CC MYERS, INC.
 JOB 215 TEMP BYPASS STRUCTURE
 DC-0011
 215-103

04-0120R4
 04-SF-80-12.3/13.2
 B.O. 12/02/03

Figure 4.2: Schematics Elevation and plan-Articulation of Temporary Bypass Structure

Figure 11.0: Typical Section-Existing YB4 Truss Span

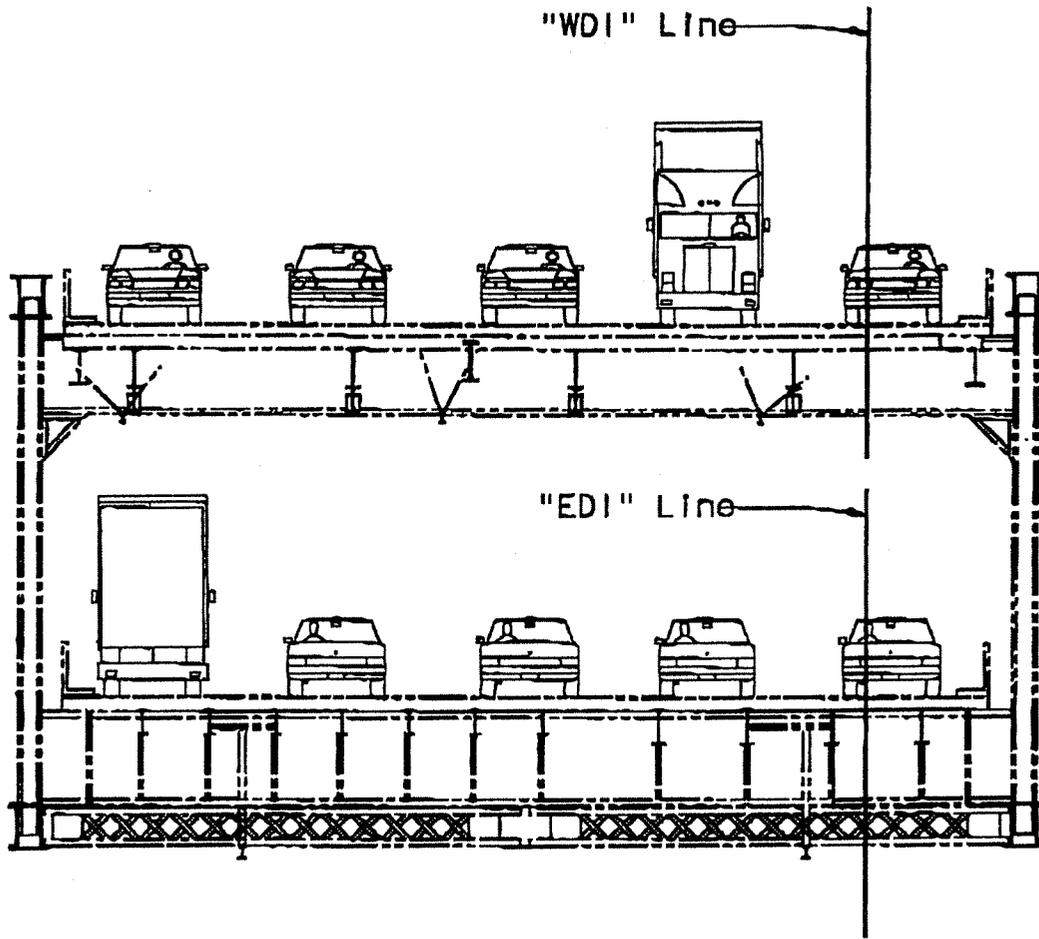
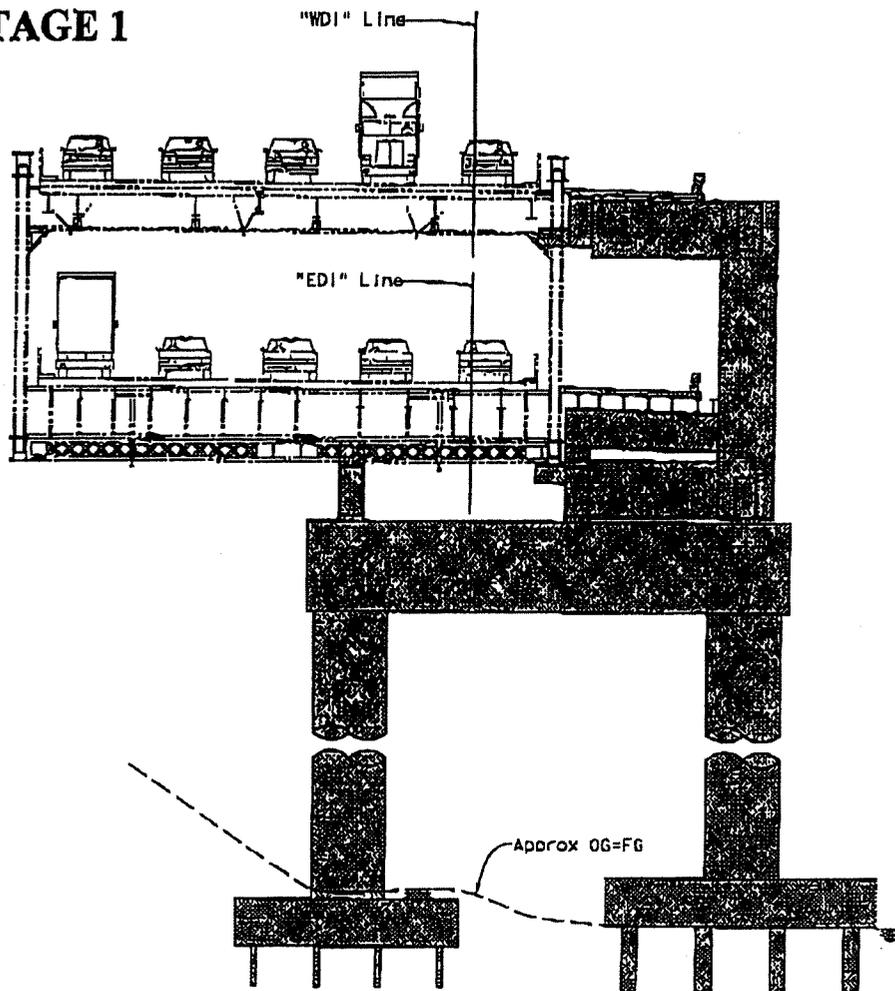
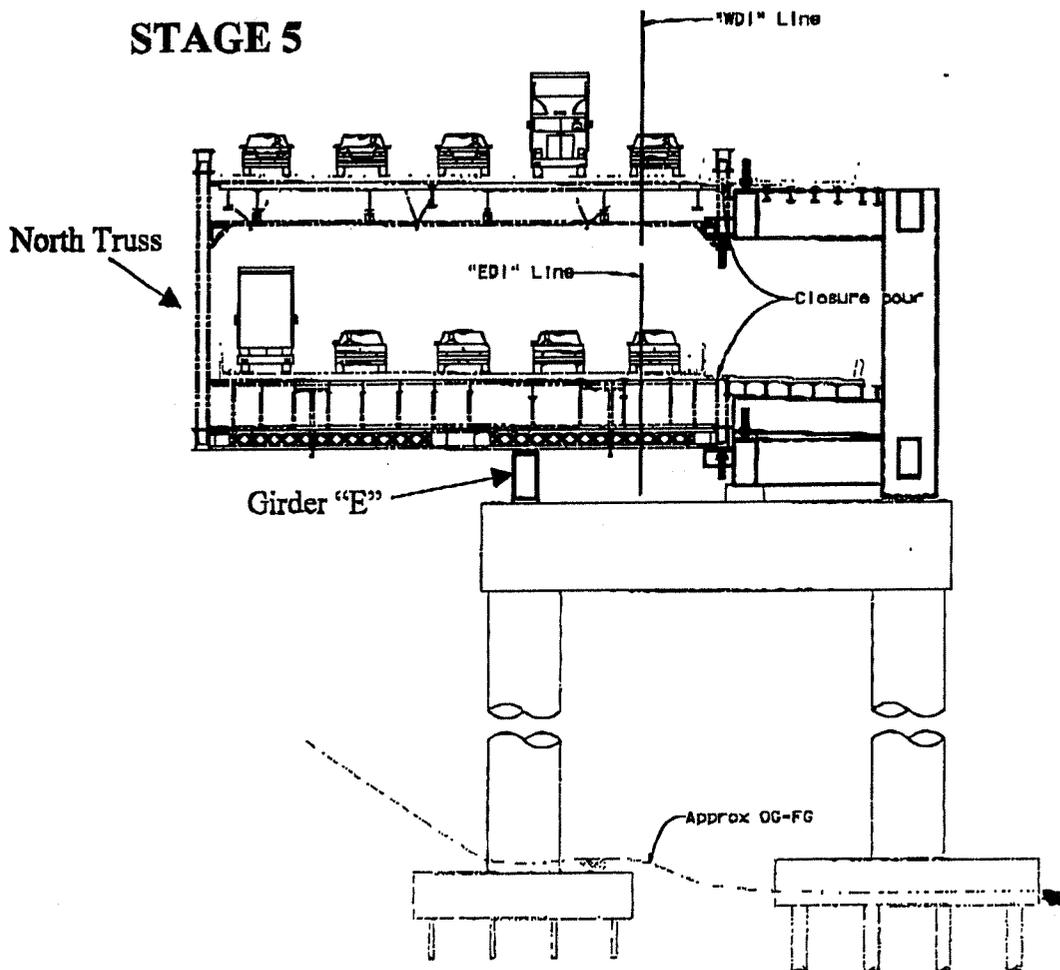
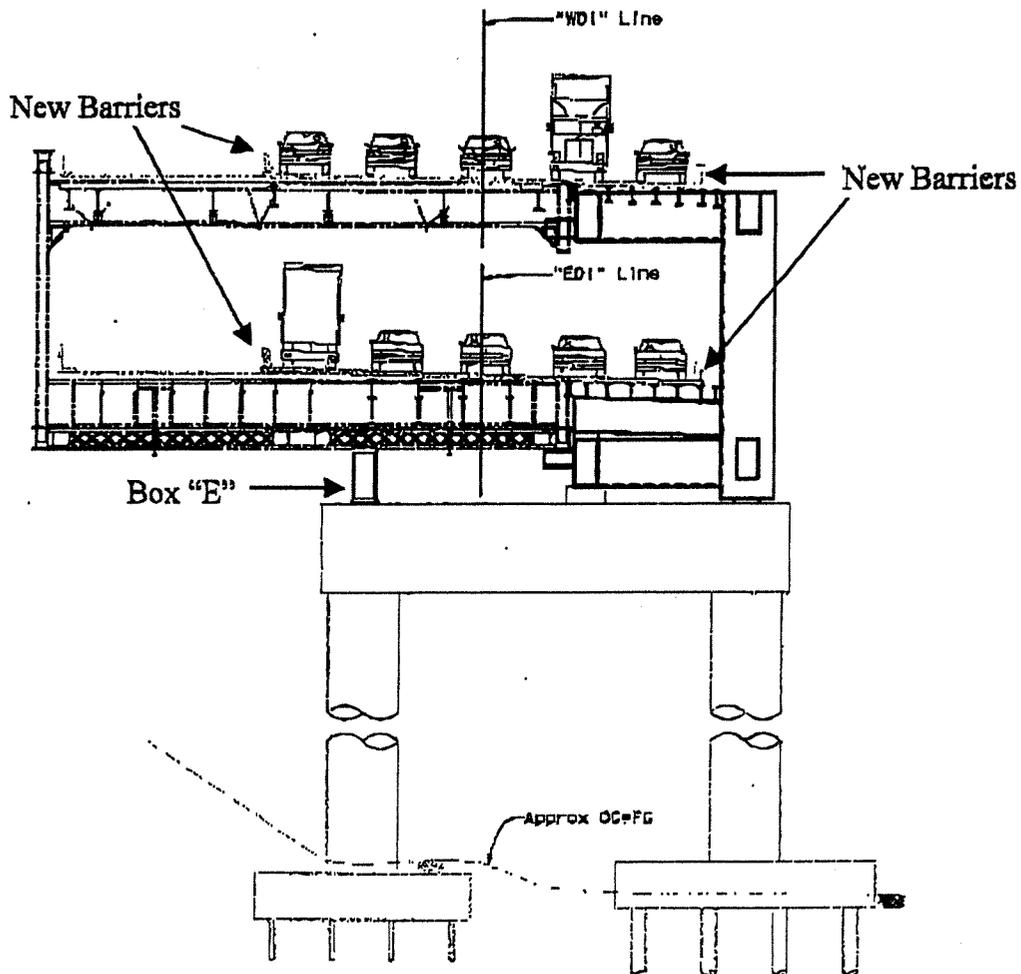
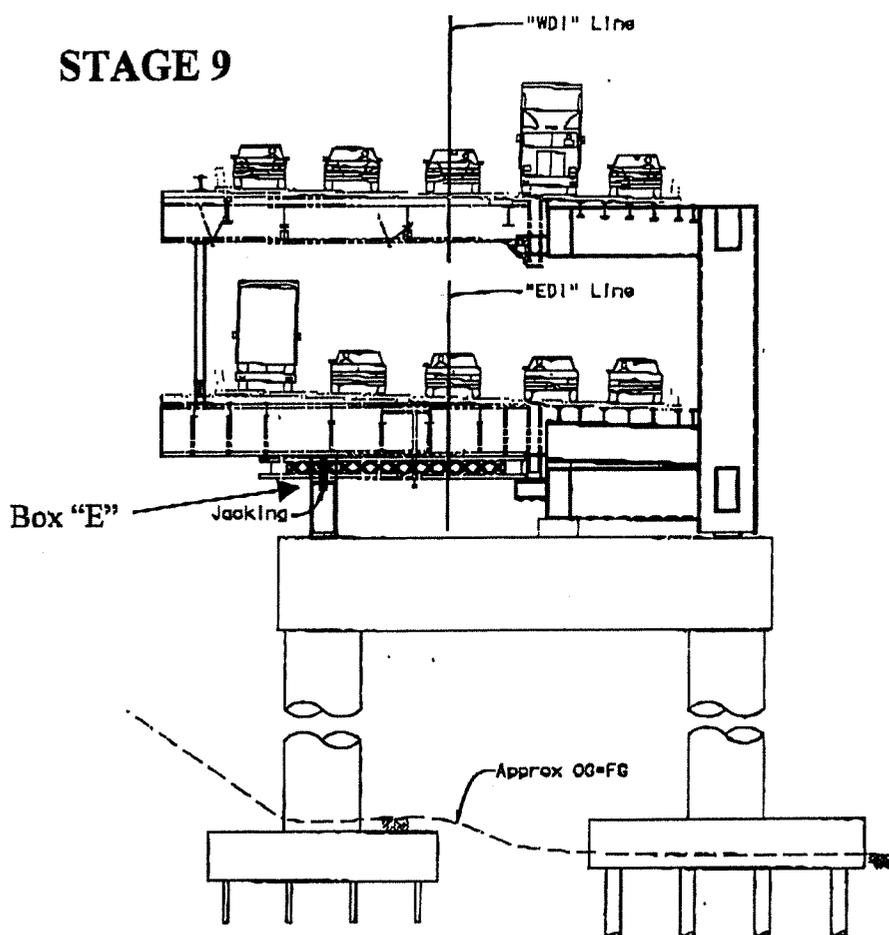
No.	Comment Date	Section number	Title	ETI Design Criteria COMMENTS	Response Date	Status	*Response by Oversight Engineer to Reviewer's comment, if required.	Verify
			East Tie-In Design Criteria, comments by Structure Construction					
		10		The last paragraph of Section 10 prior to Section 10.1 makes mention of Figure 4.7.1b. Where is this figure located?				
		11		Please expand more upon the procedures by which sensitivity studies will be conducted. What is meant by using variation of 25% of predicted jacking values.

A load limiting device as shown in Figure 4.7.1b is placed at the connection between Pier E1 and the East Tie-In. Where is Figure 4.7.1b? The load limiting device is unidirectional and will limit the loads imposed on the East Tie-In in the transverse direction.
